ADMINISTRATIVE REPORT

Title: DAV 25-117254\C – 436 Balmoral Street

Issue: For a Variance associated with an 18-storey 150-unit multi-family dwelling.

DESCRIPTION
Site Plan

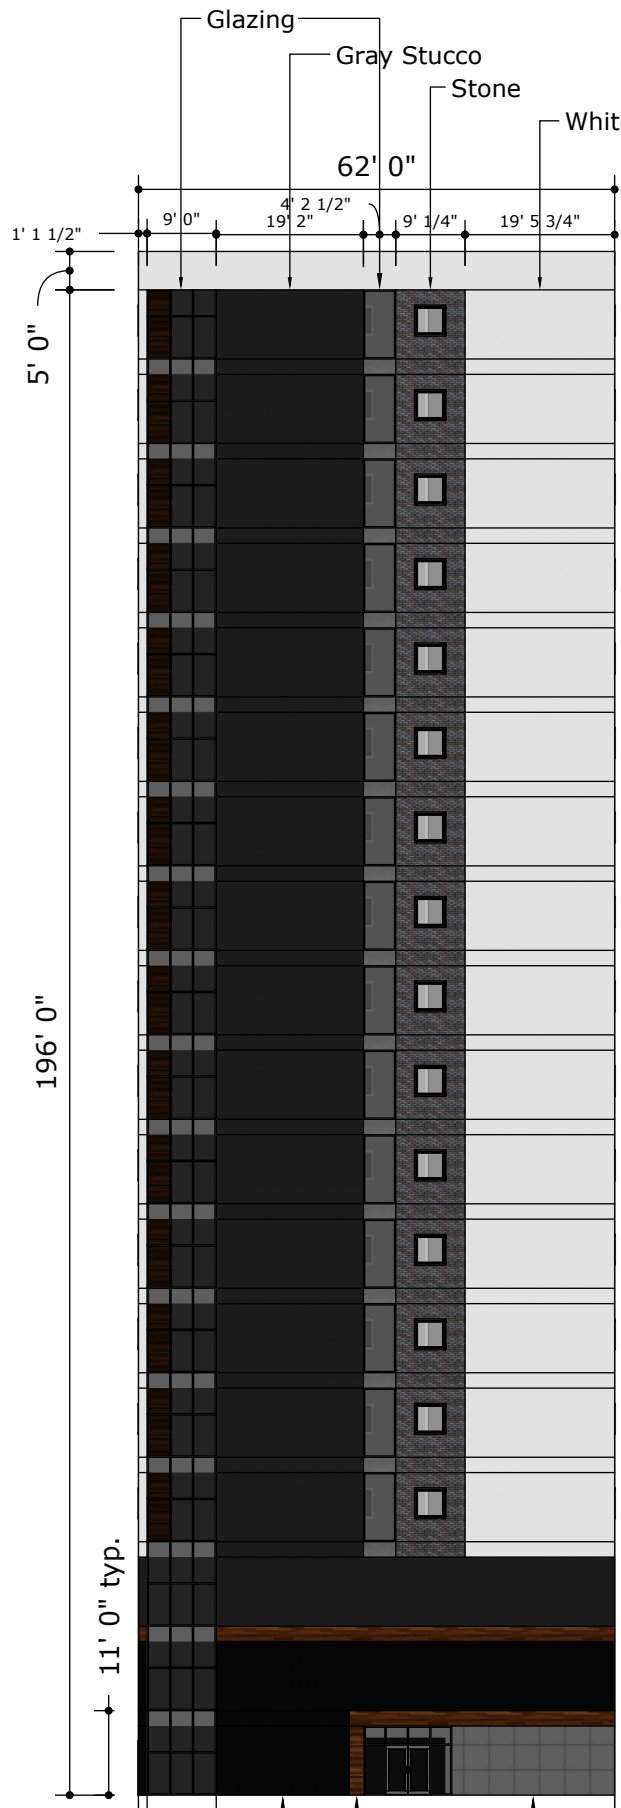
Reduced Yard Setbacks:

- The rear and side yard setbacks for proposed Lot 2 pose potential negative impacts on the amenities, use, safety, and convenience of the adjoining and adjacent properties, particularly for the tenants at the existing 3 ½-storey multi-family dwelling at 436 Balmoral Street as well as for the neighbouring residents to the rear of the overall proposed development on Spence Street.

Reduced Front Yard Building Alignment:

- The development on proposed Lot 2 is proposing a 4-foot front yard setback whereas the front yard building alignment is 8 feet. For a medium or large scale building in this location, the Division believes that 8 feet or a slight reduction is supportable but that 4 feet does not provide enough setback nor space for required landscaping.

Insufficient Street Edge Landscaping:

- The provision of street edge landscaping improves the public realm and provides a pedestrian orientation along Balmoral Street. However, there are zero (0) trees provided for proposed Lot 2.

Only one (1) tree is required to meet the *Winnipeg Zoning By-law*. The inability to provide tree(s) here is related to the reduced 4-foot front yard which is not supported by the Division.

East Elevation

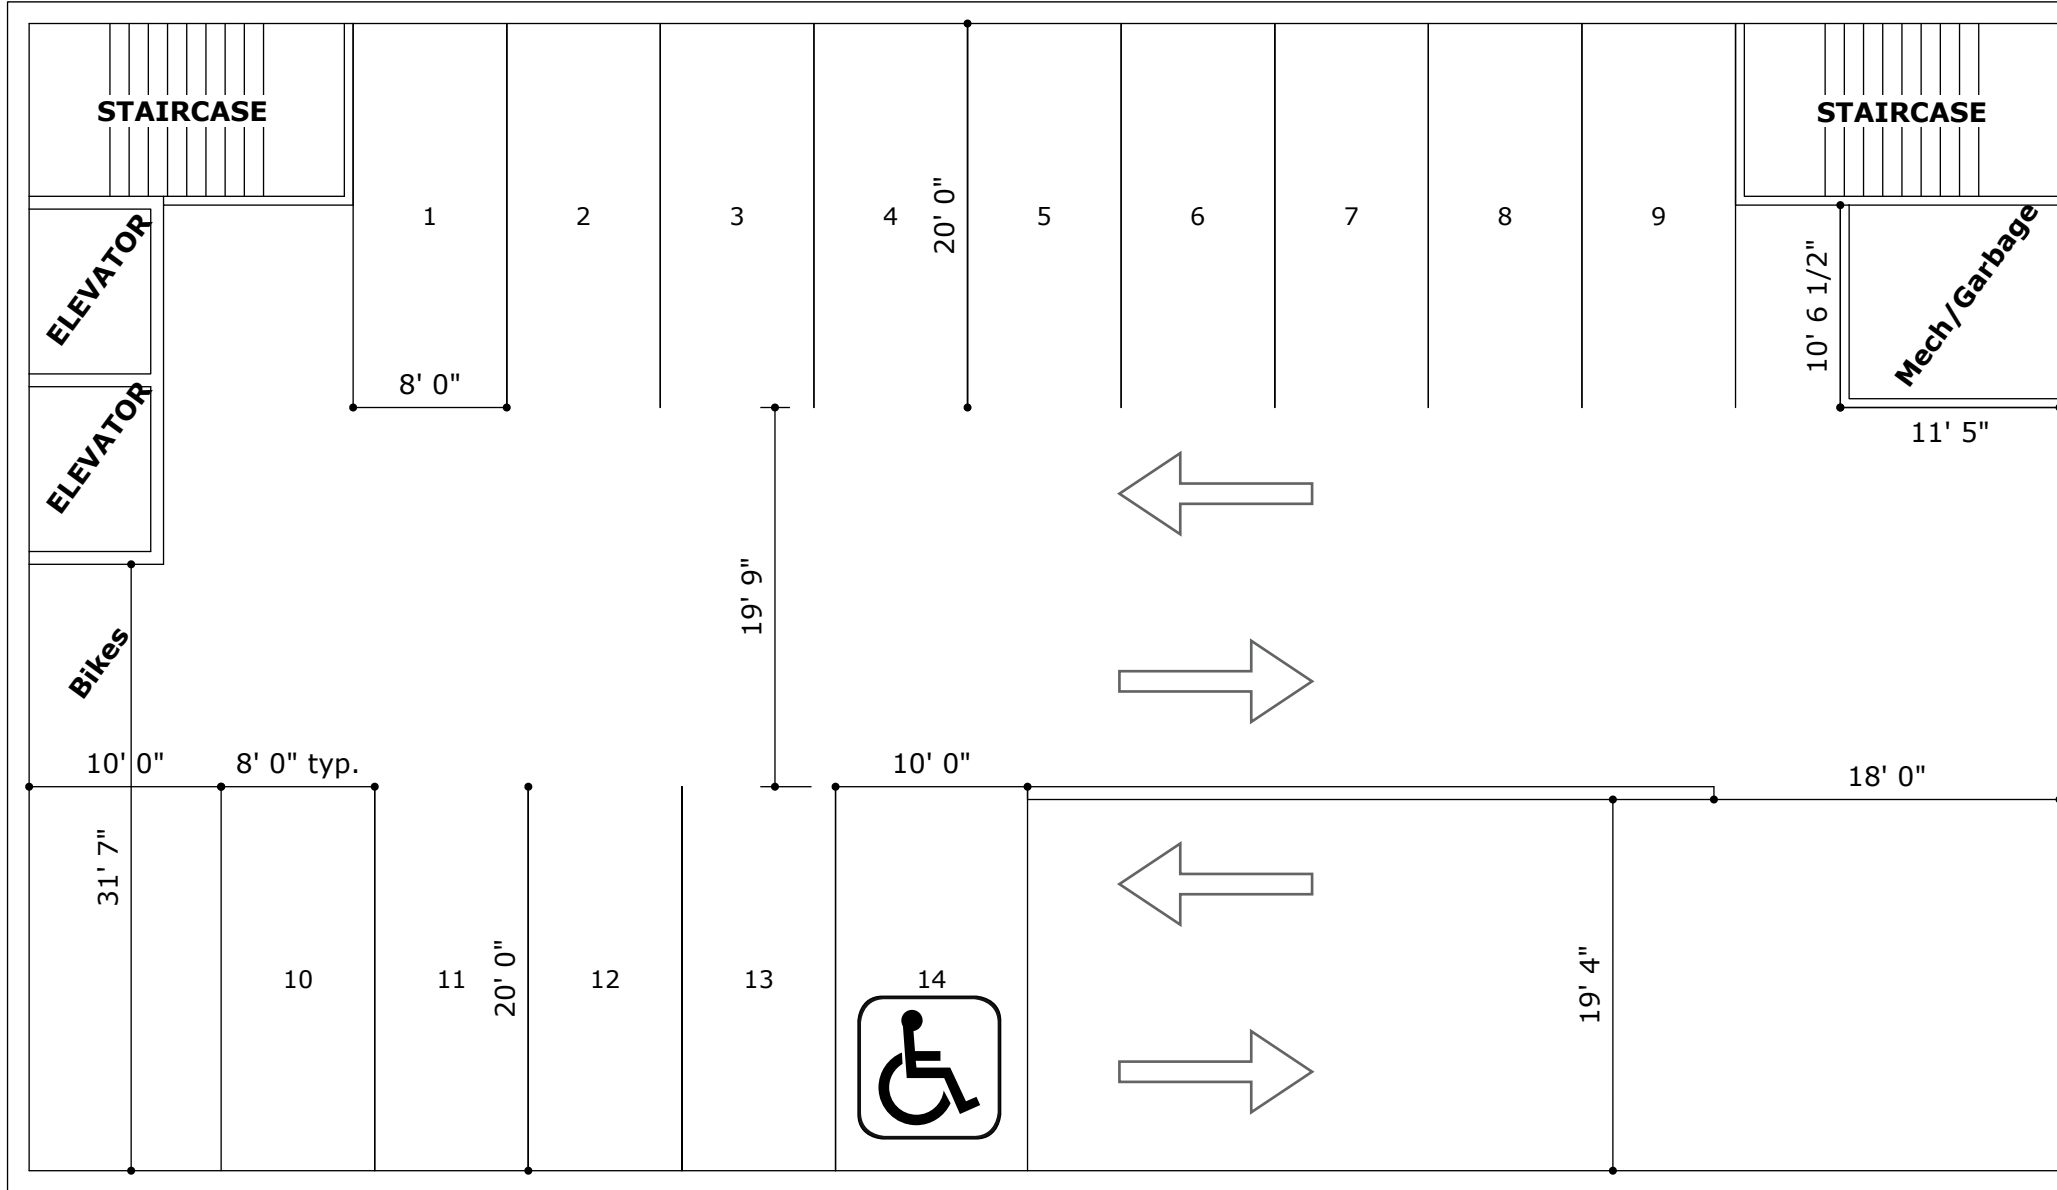
Increased Building Height:

- In *CCDS 2.0*, the residential height for sites in Established Neighbourhoods – Mature Communities along arterials streets is intended to accommodate mid-rise residential uses which allows predominately medium scale multi-residential buildings 4-8 storeys in height.

- The proposed height for Lot 2 is 18-storeys and thus does not meet the policies outlined in *CCDS 2.0*.
- There is no precedent in the Spence neighbourhood of buildings at or near this height of 196 feet (59.72 metres).

- The proposed building height is an over 30% increase to the permitted maximum *Winnipeg Zoning By-law* building height of 150 feet (45.72 metres). Even if the proposal was for an “RMF-L” zoning compliant height of 150 feet (45.72 metres), it is important to note that all dimensional standards of the *Winnipeg Zoning By-Law* for a given zoning district are to be taken together. A maximum height is tied to “RMF-L” minimum yards, parking, landscaping and other regulations, which are not met in this proposal.

- The building of this height poses potential negative impacts on the amenities of the adjoining and adjacent properties, particularly for the tenants at the existing 3 ½-storey multi-family dwelling at 436 Balmoral Street as well as for the neighbouring residents to the rear of the overall proposed development on Spence Street.
